Appin Mine Community Consultative Committee and Menangle Advisory Panel Meeting

Appin Mine Ventilation and Access Project

25 January 2022

Figure 1 Map provided in request for information (alternate location is darkest black circle)

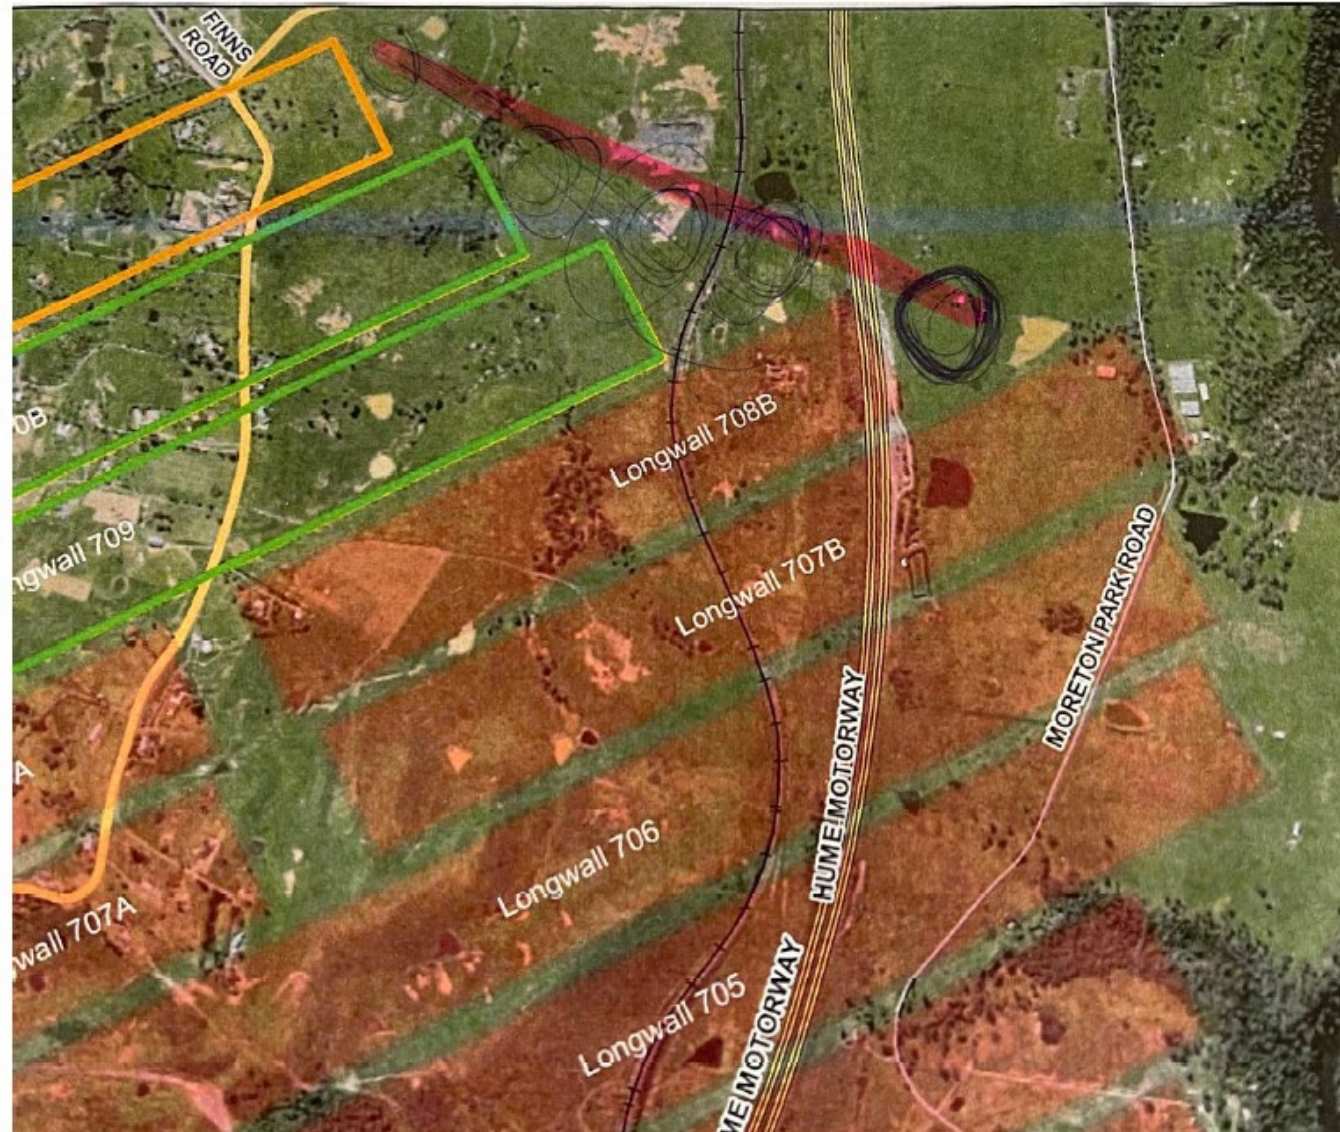
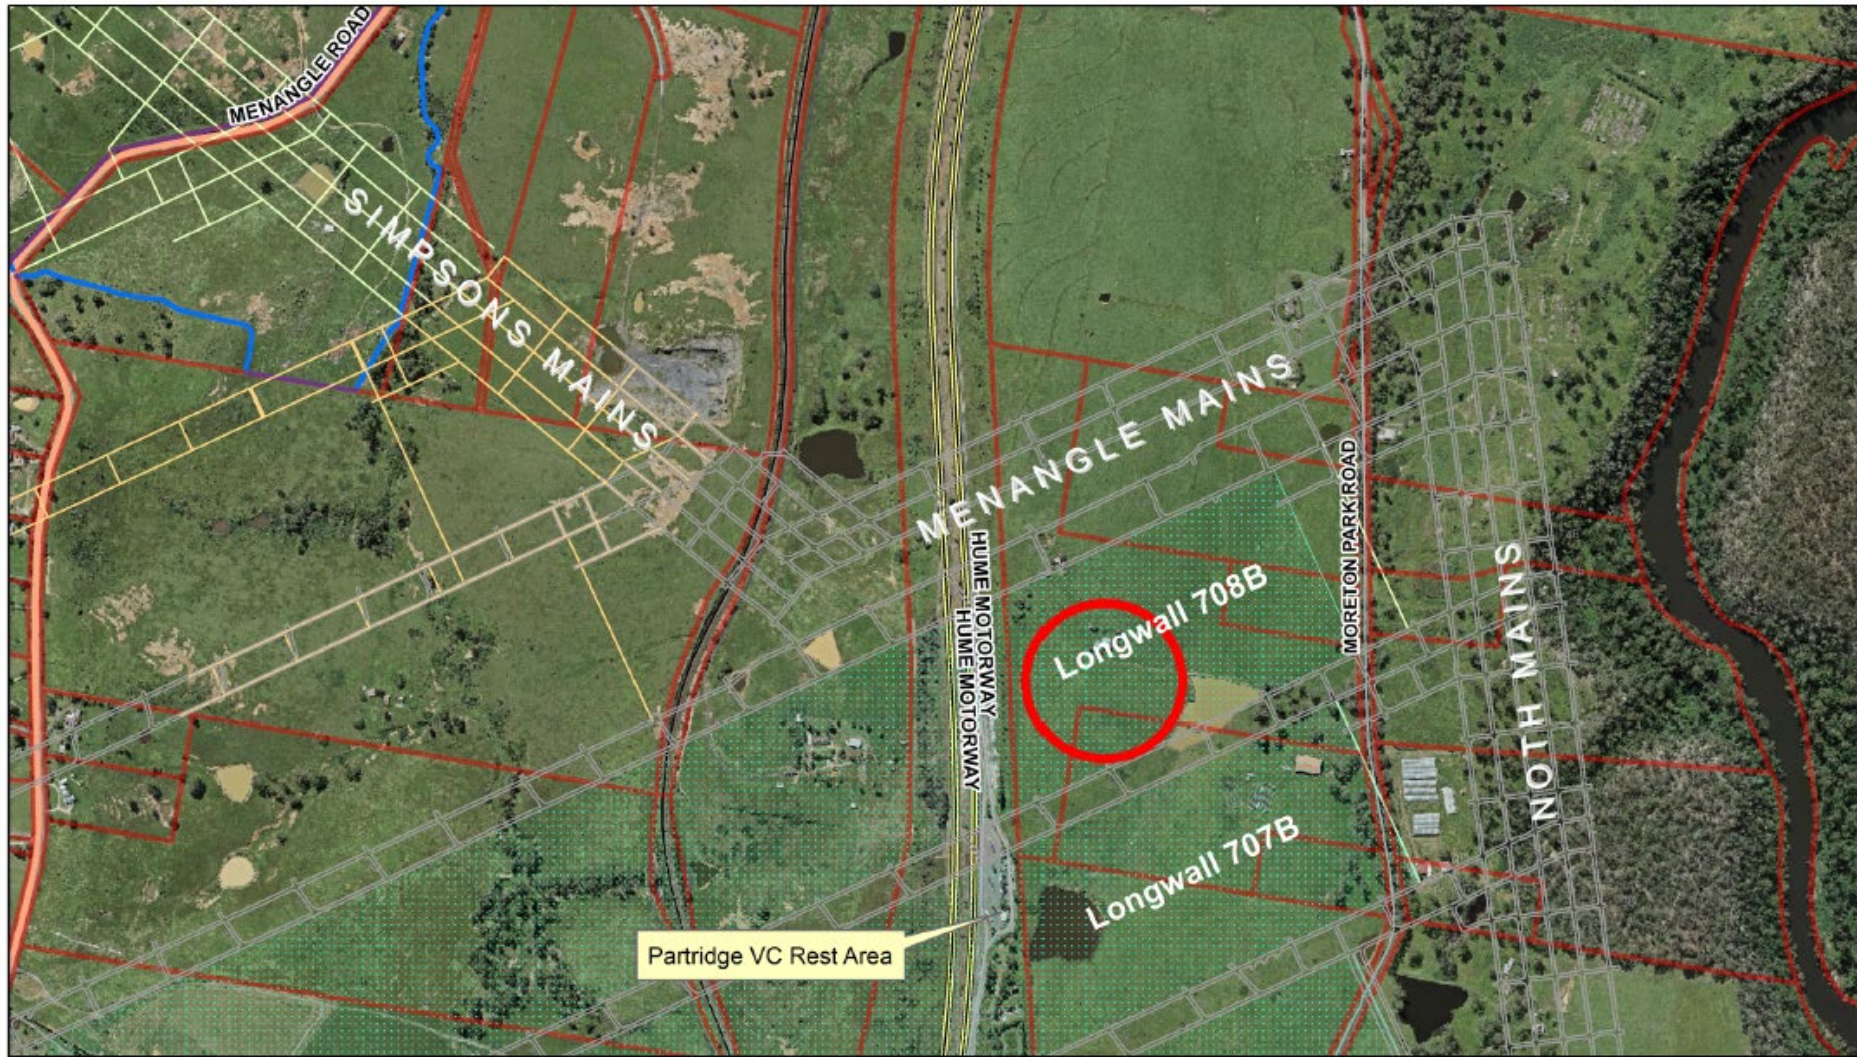
- South32's response to DPIE of 26 Nov 2021 (p4-8) regarding alternative locations above the Simpson mains, neglects to exclude any of the alternative locations directly above the Simpsons Mains. One can therefore deduce that these locations are indeed suitable locations.
- I presume South32 is now comprehensively assessing these locations with a view to relocating the project. If so, please provide details and if not, then why not?

- **The factors considered for site location have been well documented**
- This location is the optimal location of the available land above Simpsons Mains
